Process Sheet

Customer : CU-DAR001 Dart Helicopters Services	Drawing Name : HELI UTILITY BASKET LH/RH 350/355
Job Number : 38726	
Estimate Number : 10208	
P.O. Number :	Part Number : D350607043
This Issue : 22/04/2008 S.O. No. :	Drawing Number : D350-607 REV F P7-9
Prsht Rev. : NC	Project Number : N/A
First Issue : // Type : LARGE FAB ASSY	Drawing Revision : F
Previous Run : 38725	Material :
Written By :	Due Date : 10/05/2008 Qty: 1 Um: Each
Checked & Approved By : <u>JLD 08.4.02</u>	
Comment : Est Rev:E as Per DSI9318 06-01-24 JLM	
Est Rev:F ECN1068 07-12-21 DD verified by:

DART SERVICE INSTRUCTION

TO AMEND INSTALLATION INSTRUCTIONS D350-607 REV. F

DESIGN <i>CP</i>	DRAWN BY <i>CP</i>	DART AEROSPACE LTD HAWKESBURY, ONTARIO, CANADA	
CHECKED <i>[Signature]</i>	APPROVED <i>[Signature]</i>	DRAWING NO. DSI 9318	REV. A SHEET 1 OF 1
DATE 06.01.06		TITLE WASHER ADDITION	SCALE NTS
A	06.01.06	NEW ISSUE

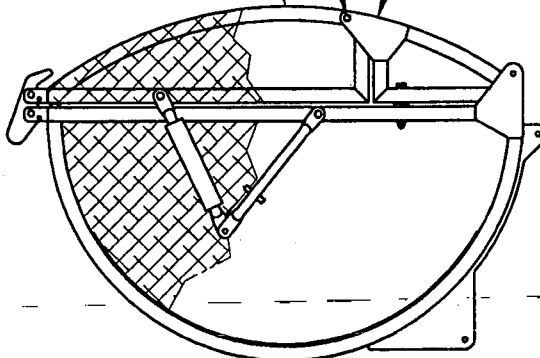
To reduce the possibility of damaging the finish, a **NAS1515H4** washer (2 places) has been added between the hinge plate and basket frame on the **D350-607-043/-047 Heli-Utility-Basket**.

The corrected bolt stackup from Figure 5 of installation instructions D350-607 Rev. F is given below:

AN4-13A BOLT (1)
AN960JD416 WASHER (1)
HINGE PLATE (REF)
NAS1515H4 WASHER (1)
BASKET FRAME (REF)
AN960JD416 WASHER (1)
MS21042L4 NUT (1)
(2 PLACES)

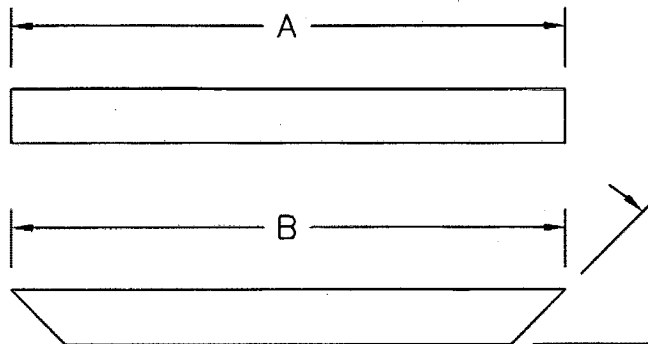
H 06.04.22
UNDER REVIEW
08.02.05 *H*
TUBING TO BE
CHANGED TO
WALL
RETURN TO
ENGINEERING
UNCONTROLLED COPY
SUBJECT TO AMENDMENT
WITHOUT NOTICE
WORK ORDER
NO. 387265

- 1) CUT LENGTH/SHAPE PER DIAGRAM AND PARTS LIST
- 2) MATERIAL: AISI 304/316 SS, 3/4 X 3/4 X 0.060 WALL SQUARE TUBING
(REF. DART SPEC M304TS0.750W.060) 0.065 *H* 06.04.22
- 3) TOLERANCES ARE PER DART QSI 018 UNLESS OTHERWISE NOTED
- 4) ALL DIMENSIONS ARE IN INCHES
- 5) DRILL $\phi 0.257$ HOLES ONLY WHEN ASSEMBLING D2221 BASE WITH
D2989-041/-043 BASKET LID

DESIGN	BW	DRAWN BY	PH	DART AEROSPACE LTD HAWKESBURY, ONTARIO, CANADA	
CHECKED		APPROVED		DRAWING NO.	REV. F
DATE	05.06.07			D2221	SHEET 2 OF 3
				TITLE	SCALE
				BASKET BASE ASSEMBLY (350)	1:20

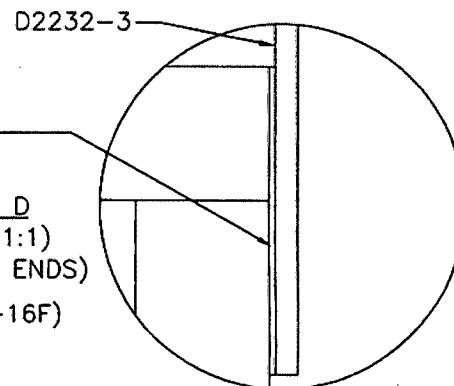
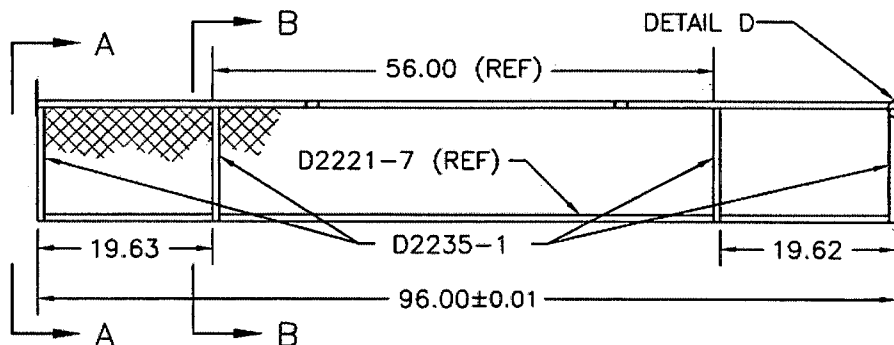
UNDER REVIEW

~~08-02-04~~
~~TUBING TO BE~~
~~CHANGED TO 0.063~~
~~INCH~~

Ref ^{WILL} 08.04.22

DESIGN BW	DRAWN BY PH	DART AEROSPACE LTD HAWKESBURY, ONTARIO, CANADA	
CHECKED <i>[Signature]</i>	APPROVED <i>[Signature]</i>	DRAWING NO. D2221	REV. F SHEET 3 OF 3
DATE 05.06.07	TITLE BASKET BASE ASSEMBLY (350)		SCALE 1:8

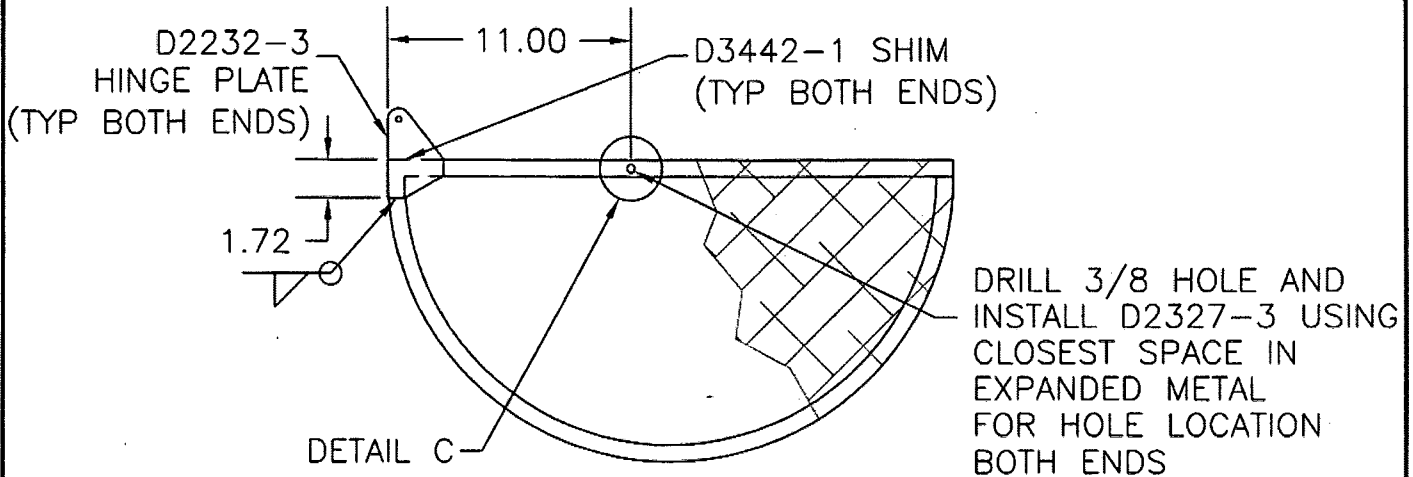
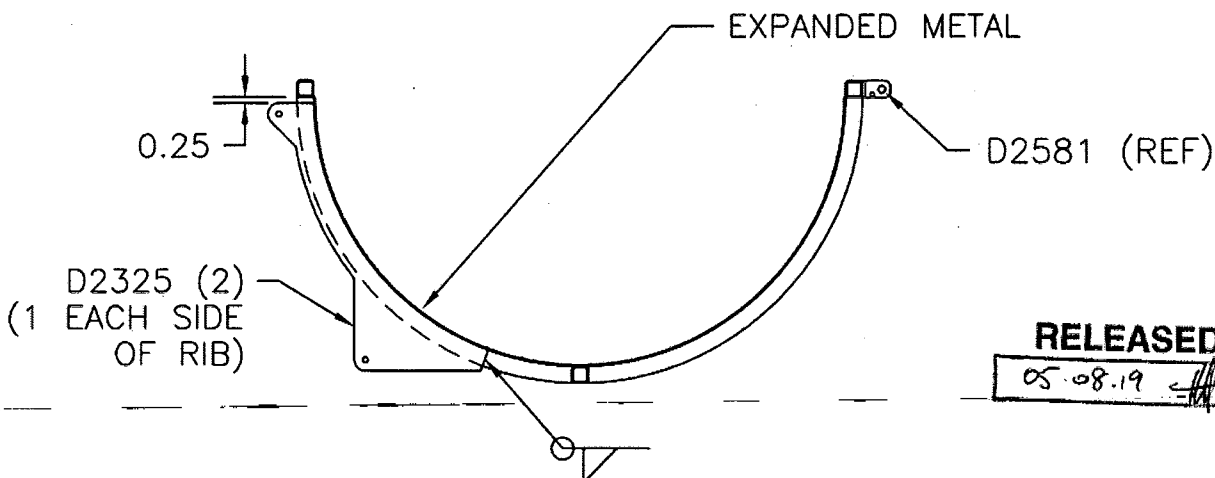
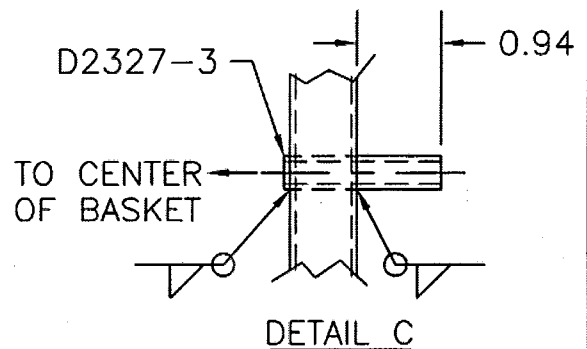
UNDER REVIEW
08.04.06 PH

TUBING TO BE
CHANGED TO 0.065
WALL
PH
01.04.02

DESIGN DS	DRAWN BY PH	DART	DART AEROSPACE LTD. HAWKESBURY, ONTARIO, CANADA
CHECKED PH	APPROVED PH	DRAWING NO. D2989	REV. B SHEET 3 OF 3
DATE 05.06.07	TITLE BASKET LID ASSEMBLY	SCALE 1:10

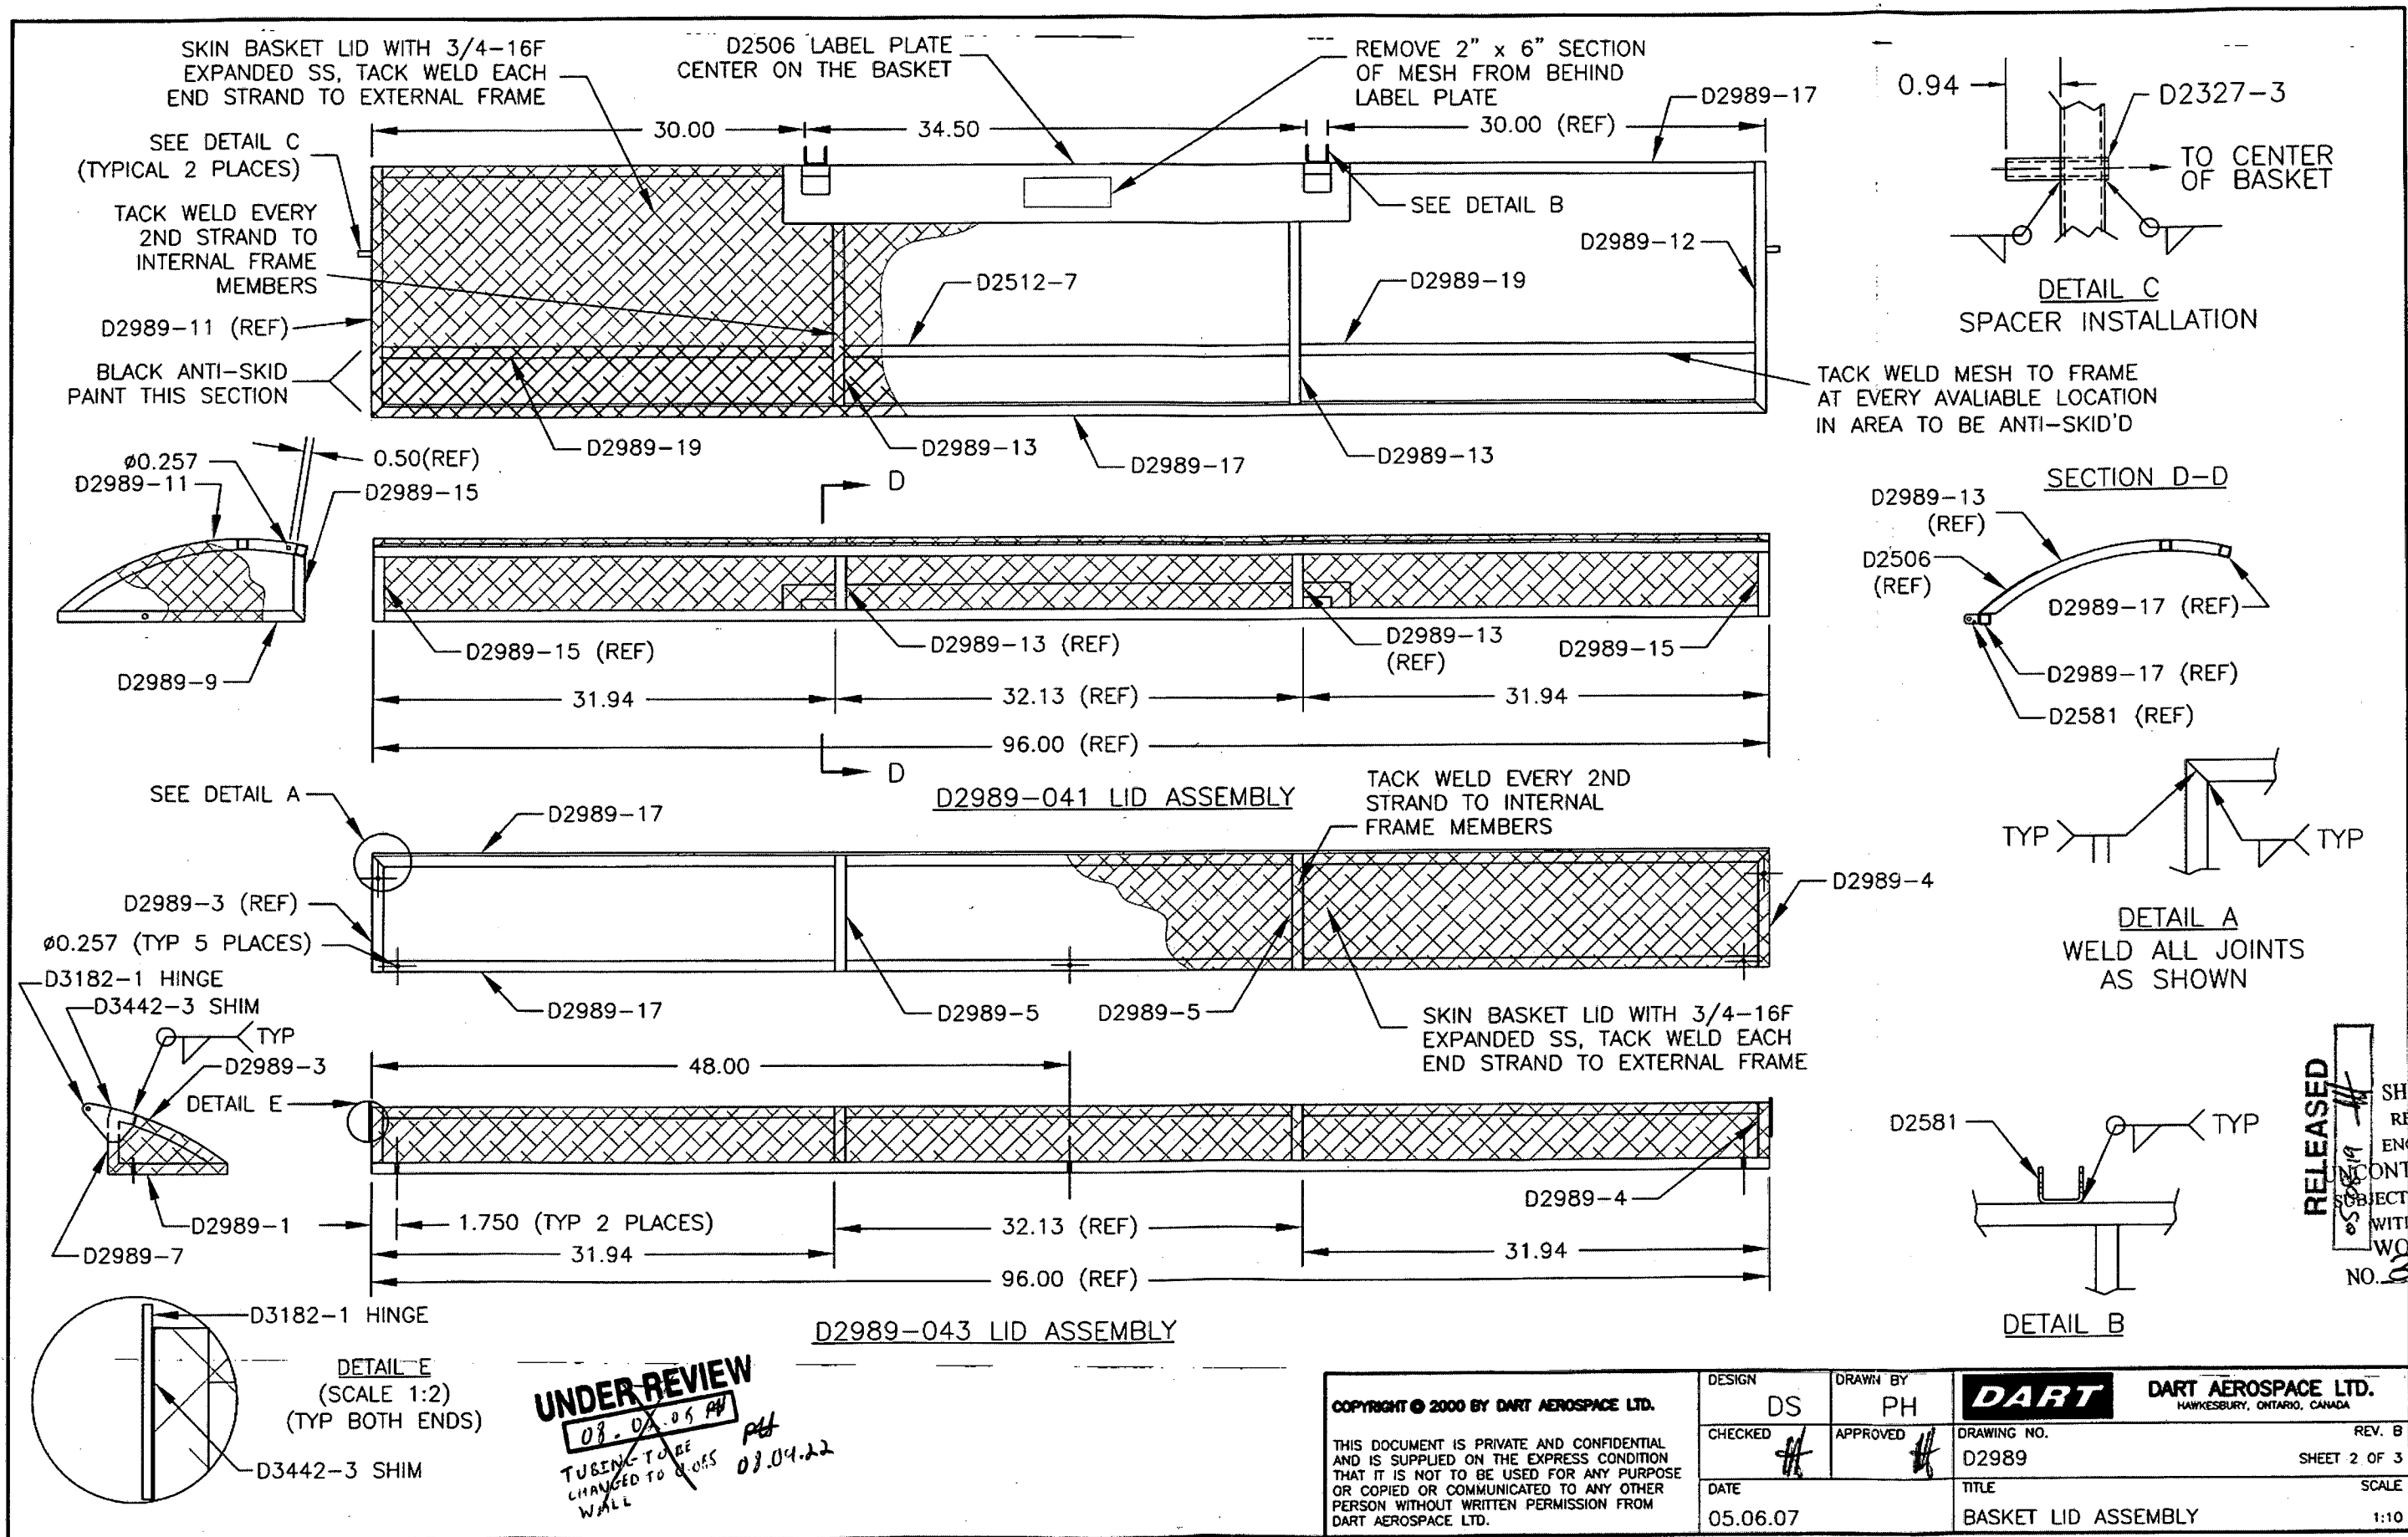
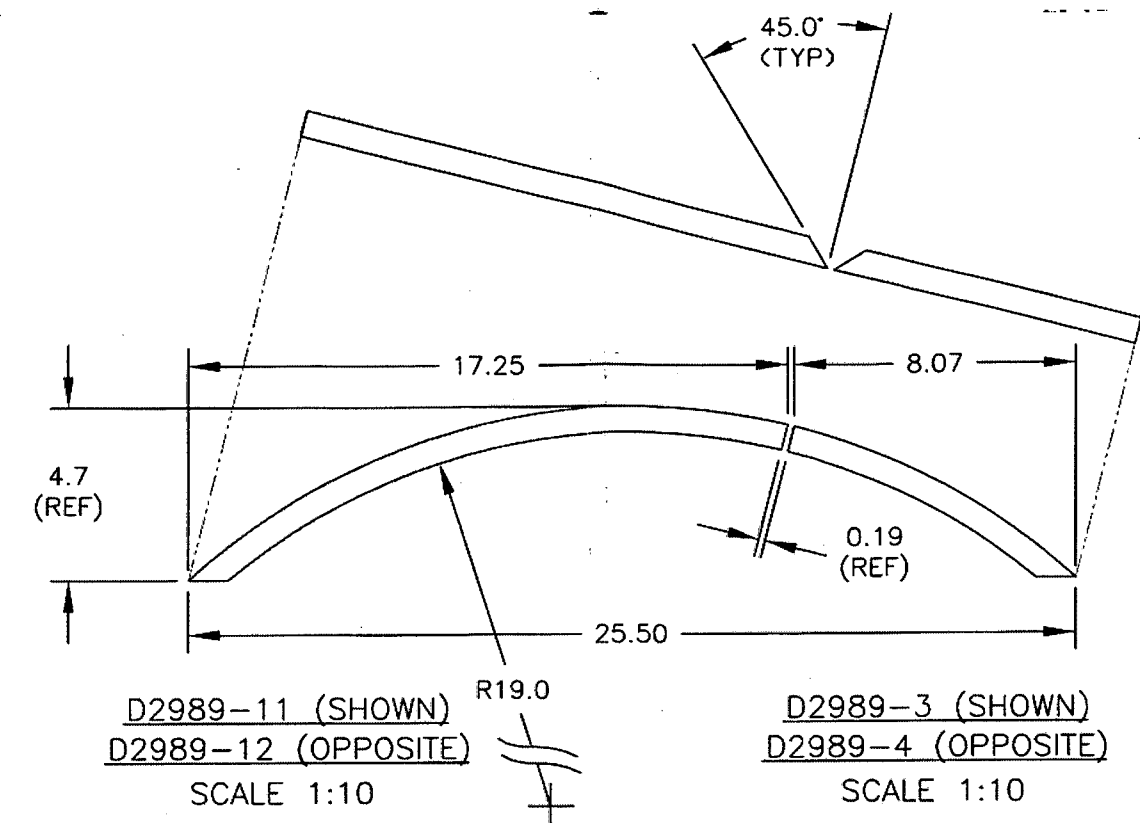
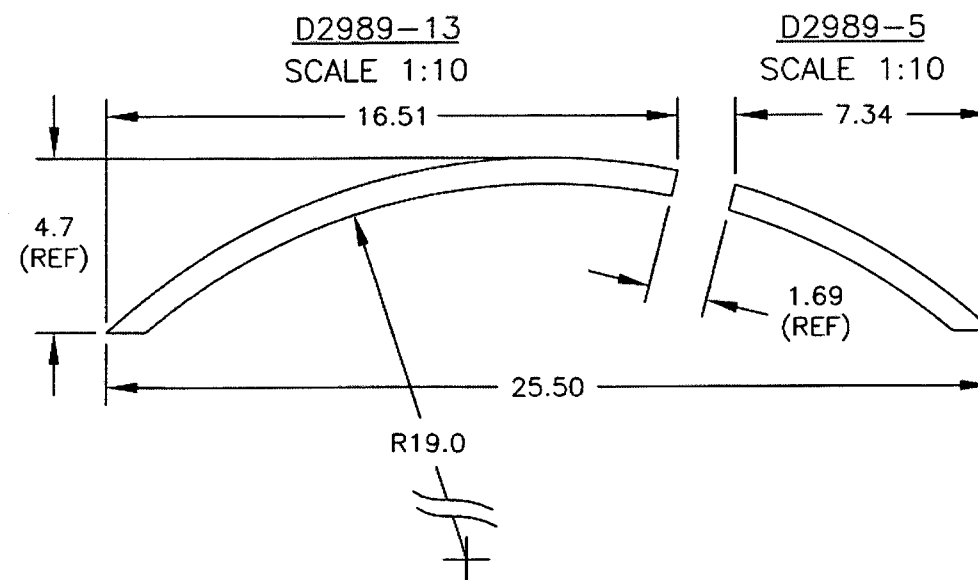
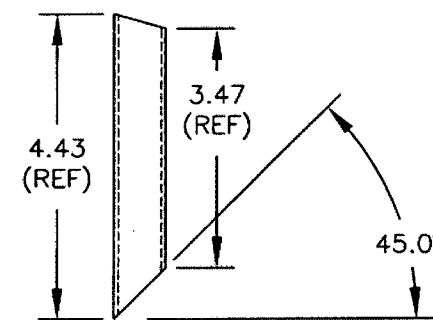
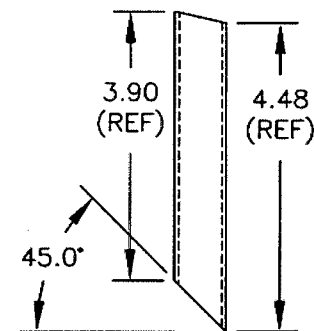
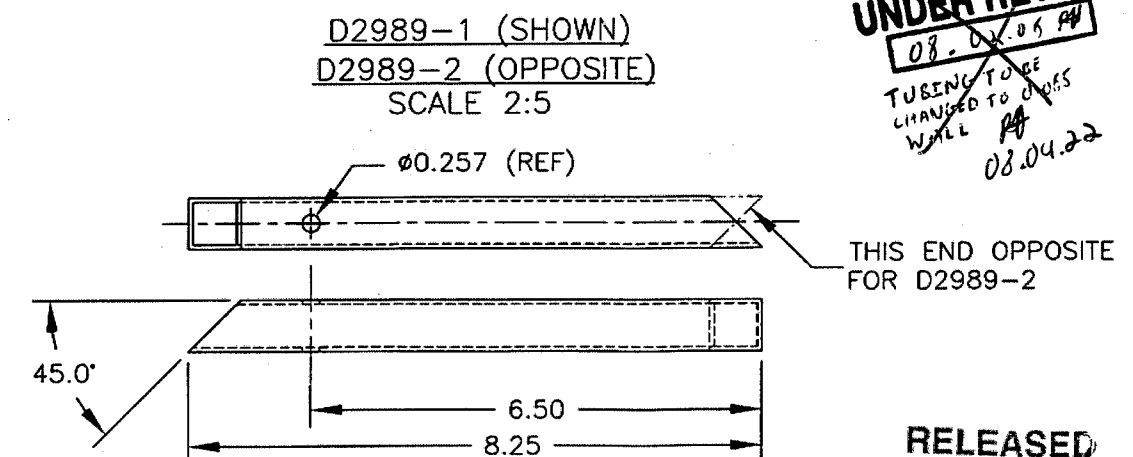
UNDER REVIEW
08.04.05 PH
TUBING TO BE
CHANGED TO Ø0.65
WALL PH
08.04.22

- 1) FRAME MATERIAL: AISI 304/316 SS, 3/4 x 3/4 x ~~0.060~~ ^{0.055} WALL SQUARE TUBING
D2989-3/4/5/11/12/13 CAN BE MADE FROM D2236
- 2) MESH MATERIAL: 3/4-16F EXPANDED SS (REF DART SPEC M304EX0.75-16F)
- 3) WELD PER DART QSI 004
- 4) FINISH: POWDER COAT WHITE (REF 4.3.5.2) PER DART QSI 005 4.3.
BLACK ANTI-SKID PAINT AS INDICATED PER DART QSI 005 4.4. SPRAY PAINT
INSIDE SURFACE BLACK PRIOR TO APPLYING ANTI-SKID.
- 5) ALL DIMENSIONS ARE IN INCHES
- 5) TOLERANCES ARE PER DART QSI 018 UNLESS OTHERWISE NOTED
